## Planning Committee A

**ROSEMOUNT POINT, DACRES ROAD, LONDON, SE23 2BW**

**Date:** 25 May 2023

**Proposal:** Refurbishment of external cladding, replacement of windows, doors, balconies, screens and roof finishes at ROSEMOUNT POINT, DACRES ROAD, LONDON, SE23 2BW.

Figure 2 Existing and proposed South West and North East

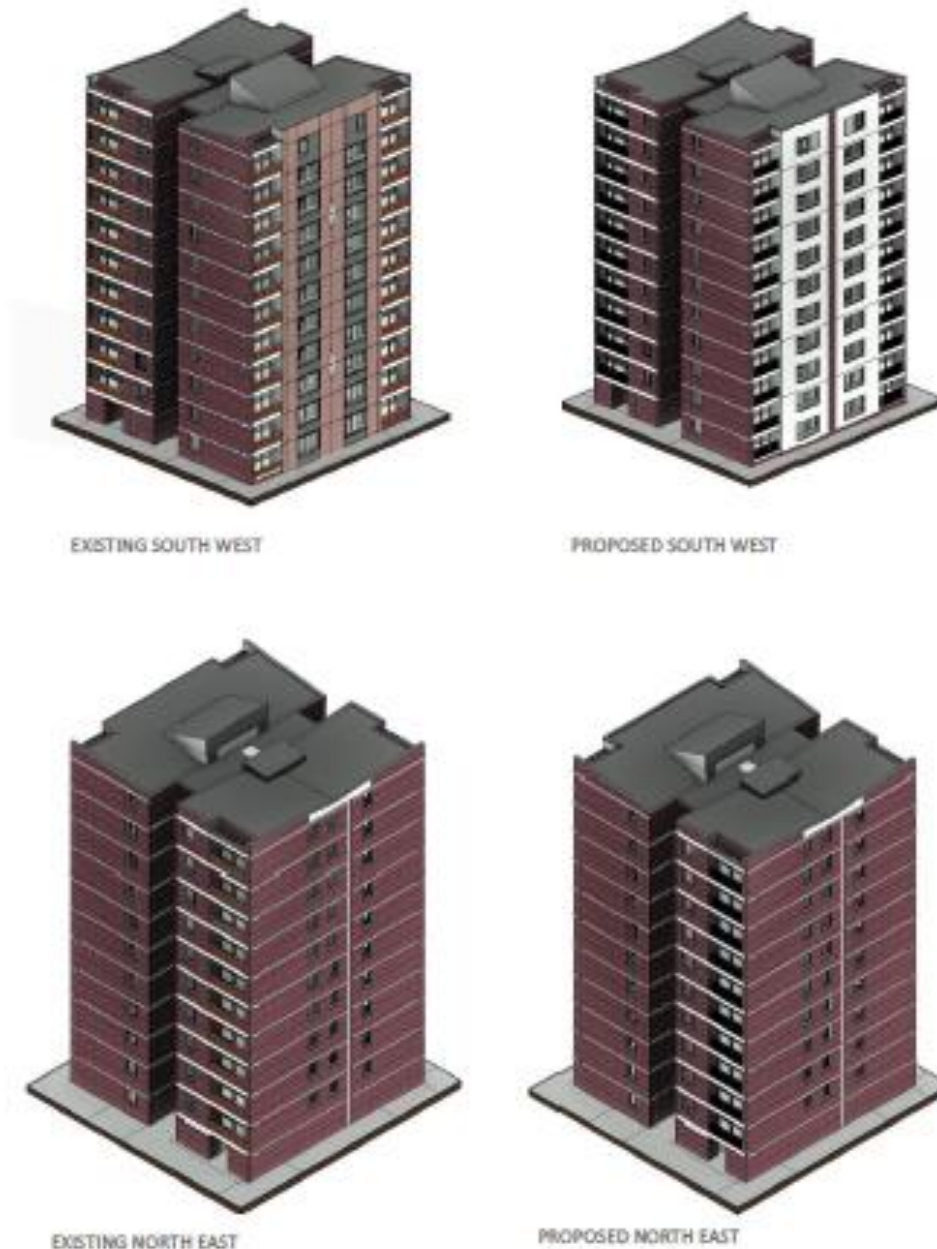
56 The existing windows are white uPVC. The proposal is to install new white uPVC double glazed in the same place and size of the existing windows and doors, style to match original. New double-glazed windows and screens are proposed to achieve a u-value performance of 0.16 W/m<sup>2</sup>K. In the D&A statement it is pointed out that installation of the new Rehau 70mm uPVC would achieve the requirements of BS EN12608:2016, Table 1.4 of Approved Document F and Approved Document K. The windows would have sills, and trickle vents, with tilt and turn hinges and restrictors, with locking handles in white. All windows with a sill height below 1000mm will require the installation of a lower-level fixed pane below the opening vent to enable the required sill height for the opening vent.

58 The windows and doors would be the same style, material, and colour as the existing. Objections were raised questioning the quality of uPVC windows: the windows proposed are of good quality and would be similar to those used on many residential buildings and are considered unobjectionable. The new double-glazed windows would improve the building's performance in terms of energy efficiency, and sound isolation, and are supported.

**Figure 4 Proposed Balustrade**

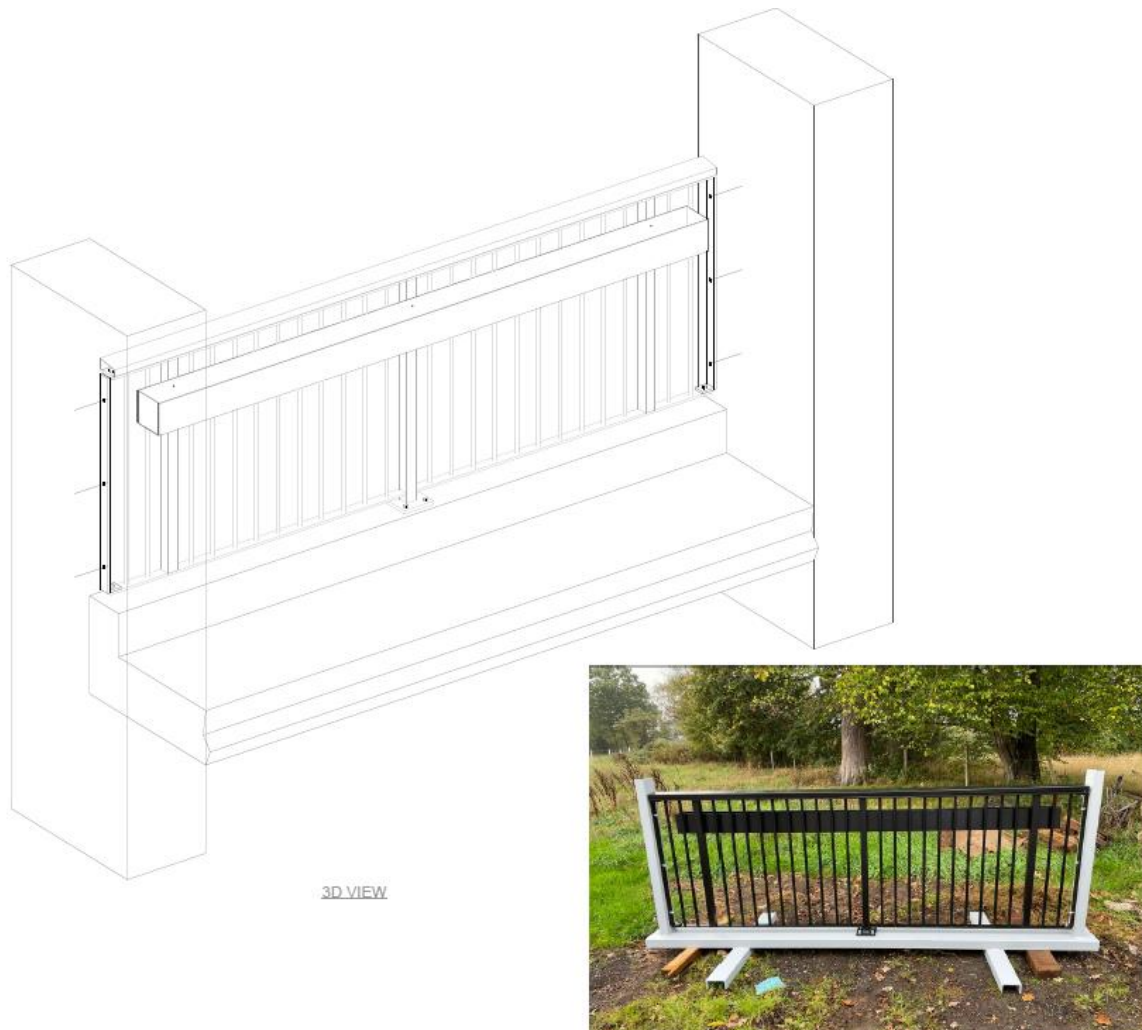
- 65 The existing timber balustrade at the balconies would be replaced with polyester powder coated aluminium balustrade to ensure compliance with both Approved Documents Part B and Part K. The colour would be dark grey RAL colour: 7022. At the ground floor, the existing masonry upstand would be retained, and the timber balustrade would be replaced with the railing.

- 67 Objections were received regarding the change of existing timber balustrades with metal railings. It is noted that timber balustrade at balconies of all of the five towers in this area are considered as an original character of these buildings. The replacement with metal railings is not considered inappropriate nor incongruous as this is a standard residential balcony enclosure. It is notable that, due to changes in the Building Regulations regarding fire safety, timber balustrades for high rise buildings such as this tower, are no longer supported.

- 68 Officers are of the view that the current timber balustrades are in poor condition, and considering the quality of the proposed materials, they are acceptable.
